APSU support for 800GBASE-ER1/ER1-20

Addresses comments #315, 126, 127, and 128 against D3.0

IEEE 802.3dj May 2026 Session

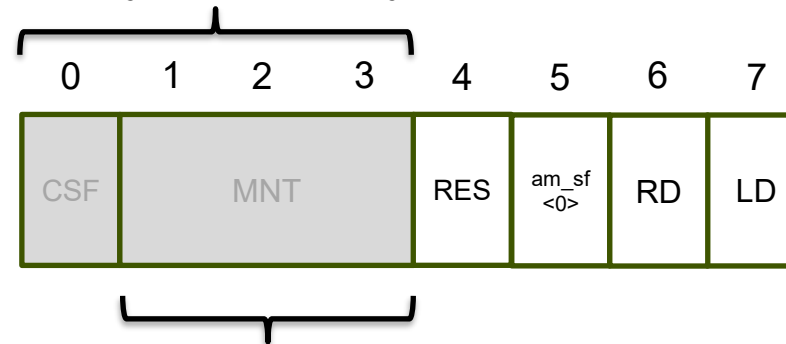
- RTS status from adjacent AUI interface is mapped to MNT field of the CSTAT octet in the 800GBASE-ER1 tributary frame overhead as shown below:

Currently not used by ER1

MNT field (3-bits) used by ZR, ZR+

Proposed modification

Value	ITU G709.1	OIF ZR, ZR+	IEEE ER1
000	Normal Operation	Normal Operation	SIGNAL_OK = OK
001	Not used	Not used	SIGNAL_OK = READY
010	Not used	Not used	SIGNAL_OK = IN_PROGRESS
011	Not used	Not used	SIGNAL_OK = FAIL
100	Reserved (SquelchText)	Reserved	Reserved
101	LCK	LCK	Reserved
110	OCI	Reserved	Reserved
111	AIS	Reserved	Reserved

Figure 186-3—800GBASE-ER1 FEC functional block diagram

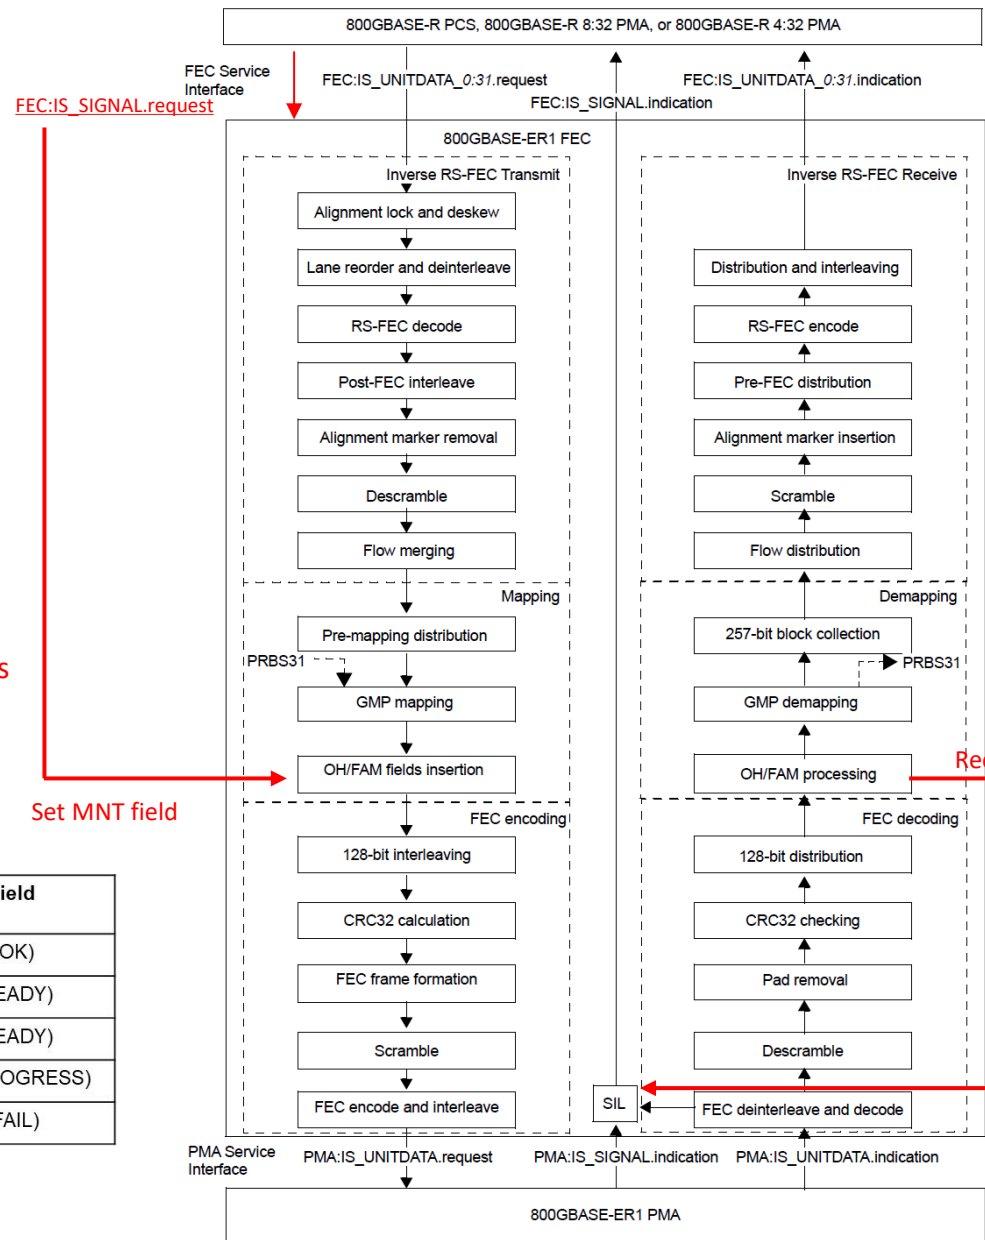
In transmit direction:

Use FEC:IS_SIGNAL.request(SIGNAL_OK) plus local status to set the transmit MNT field

In receive direction:

Use received MNT field plus local status to generate FEC:IS_SIGNAL.indication(SIGNAL_OK).

Note: This slide captures the intended behavior, but further work is required to fully define the SIL function

FEC:IS_SIGNAL.request SIGNAL_OK	align_status	MNT Field
OK	true	"000" (OK)
OK	false	"001" (READY)
READY	don't care	"001" (READY)
IN_PROGRESS	don't care	"010" (IN_PROGRESS)
FAIL	don't care	"011" (FAIL)

PMA:IS_SIGNAL.indication SIGNAL_OK	Received MNT Field	FEC:IS_SIGNAL.indication SIGNAL_OK
OK	"000" (OK)	OK
OK	"001" (READY)	READY
OK	"010" (IN_PROGRESS)	IN_PROGRESS
OK	"011" (FAIL)	FAIL
FAIL	don't care	FAIL

Figure 187-2—800GBASE-ER1 inter-sublayer service interfaces

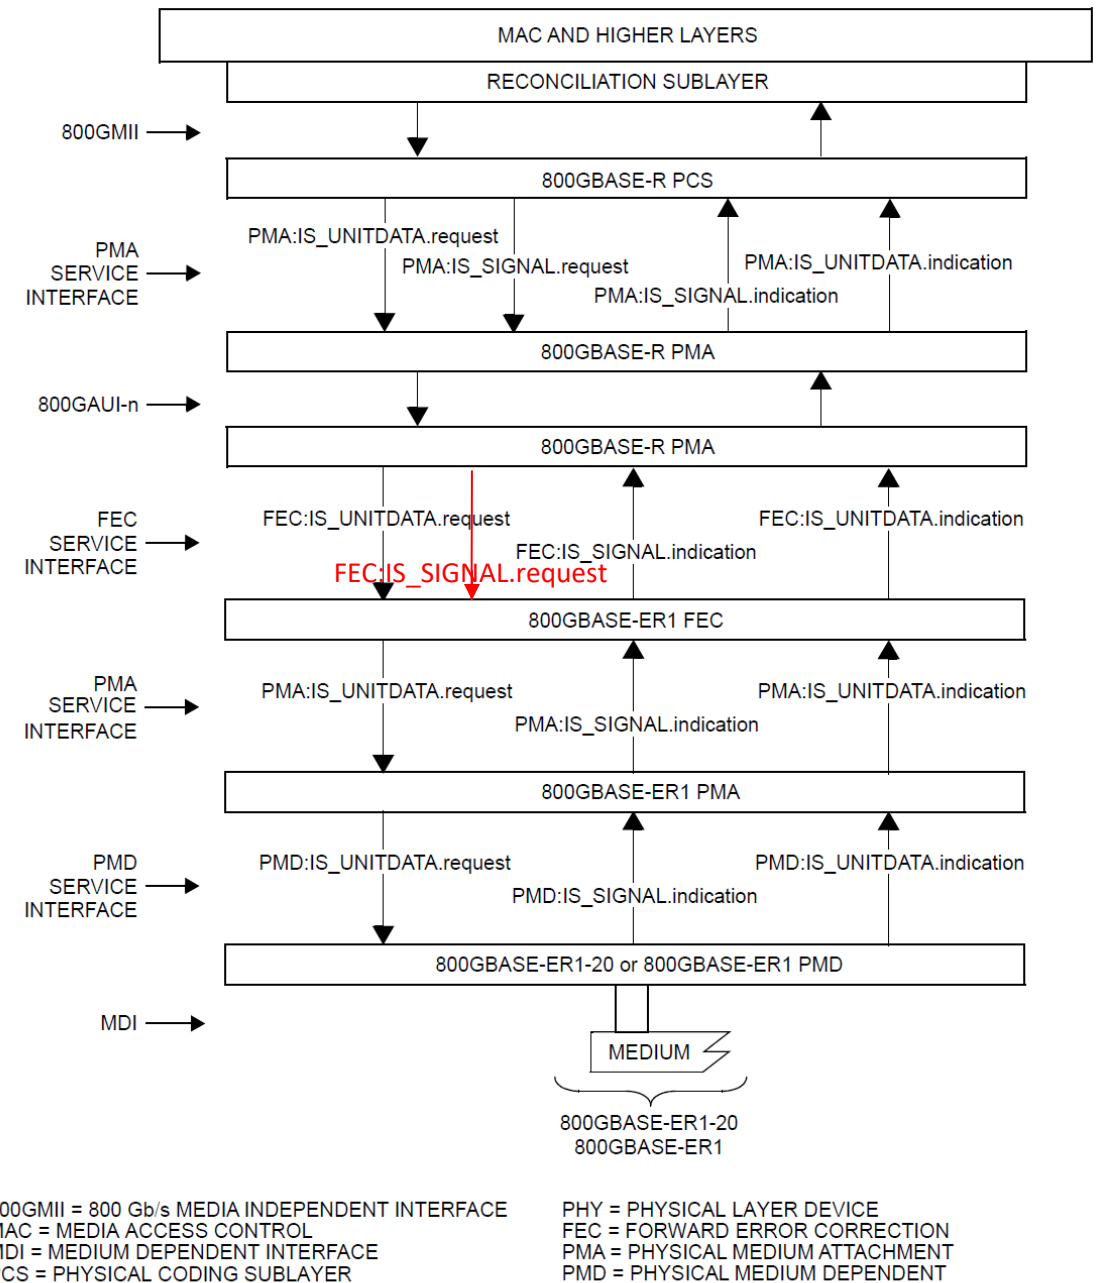
Service interface (proposed changes)

- In Cl186, add the service interface primitive **shown** to include SIGNAL_OK parameter in the transmit direction
- FEC service interface (above the 800GBASE-ER1 FEC)
 - FEC: SIGNAL.request(SIGNAL_OK)
